**Government of India**  
**Ministry of Environment, Forest and Climate Change**  
**(Forest Conservation Division)**

**Subject: Proposal for diversion of 99.256 ha of forest land for development of Dhalbhumgarh Airport in favour of Airport Authority of India in East Singhbhum district in Jharkhand State (Online No. : FP/JH/Others/41404/2019) – regarding.**

**Proposal: Diversion of 99.256 ha. Forest land for Development of Dhalbhumgarh Airport**

**Summary of DSS Analysis Report based on the details available on PARIVESH:**

**Google imagery showing the road segment which has not been included in the present proposal:**

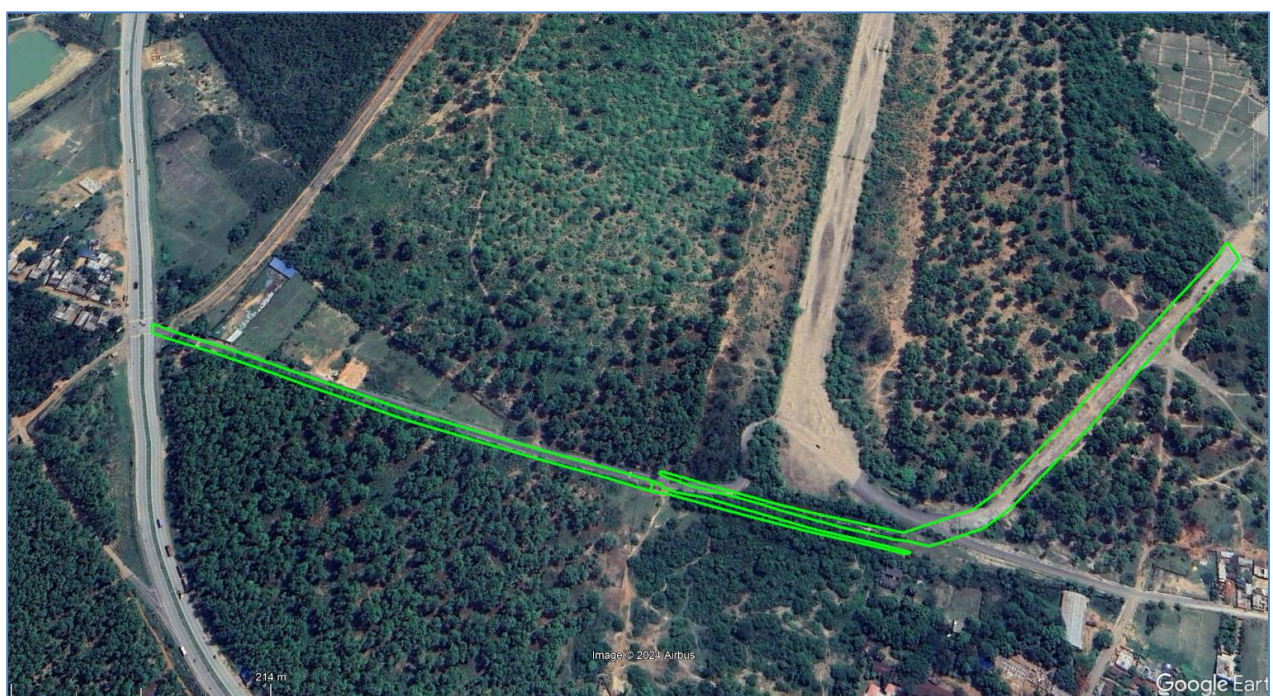
- xvi. The DSS analysis revealed that the user agency has not included some forest areas within the road segment proposed for diversion. Moreover, width of the road found decreasing from 20 meter to 3.75 meter (**Copy enclosed**). Therefore, the State Govt. shall carry out necessary correction in the KML file of proposed forest land and include complete forest land within the project boundary and shall submit the corrected KML file.

10. As depicted through satellite imagery, the user agency has not included some forest areas within the road segment proposed for diversion. Moreover, width of the road found decreasing from 20 meter to 3.75 meter.
